DRAFT  
SAFETY EVALUATION REPORT

Docket No. 72-1027  
TN-68 Dry Storage Cask  
Certificate of Compliance No. 1027  
Amendment No. 1

Figure 1 – Example TN-68 Cask Storage Configuration (Based on SAR Figure 4.10-1)

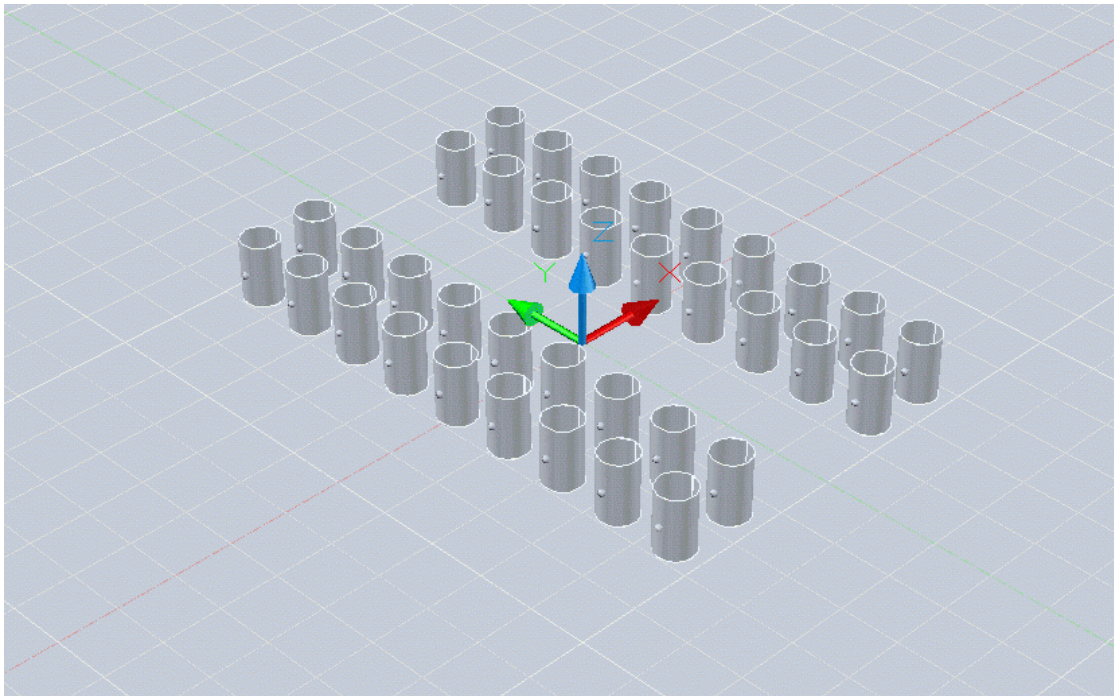
The staff determined that the view factor of the emitting cask in Figure 1 to the environment, with the concrete storage pads and access road conservatively considered to have no communication with the cask surface, was approximately 0.33. The applicant's original value of 0.62 for the view factor was considered to be non-conservative.

The staff requested that the applicant submit a calculation of the view factor in order to more appropriately capture the actual behavior of radiative exchange between a cask in an array of casks situated on a storage pad. The applicant submitted a view factor calculation that utilized the radiosity method of the ANSYS FEA code, and completed a sensitivity study of the effect of variations of the view factor on the thermal performance of the cask. The applicant documented this effort in Sections 4.10.1.1 and 4.10.1.3 of the SAR.

The staff reviewed the ANSYS model that was submitted by the applicant and found some minor errors related to the mirror plane and the resolution of the view factor calculation in the submitted model. The staff discussed the issues with the applicant, and, by letter dated March 16, 2007, the applicant provided a revised model that the staff found acceptable.

The applicant should use the modeling approach accepted by the staff for any future calculations related to the exchange of radiation between the cask and the surrounding environment for the TN-68 cask design. The applicant must consider the geometry of the cask storage pad when evaluating site specific application of the TN-68 cask design at a storage facility, since their view factor calculation method is dependent on the pad geometry.
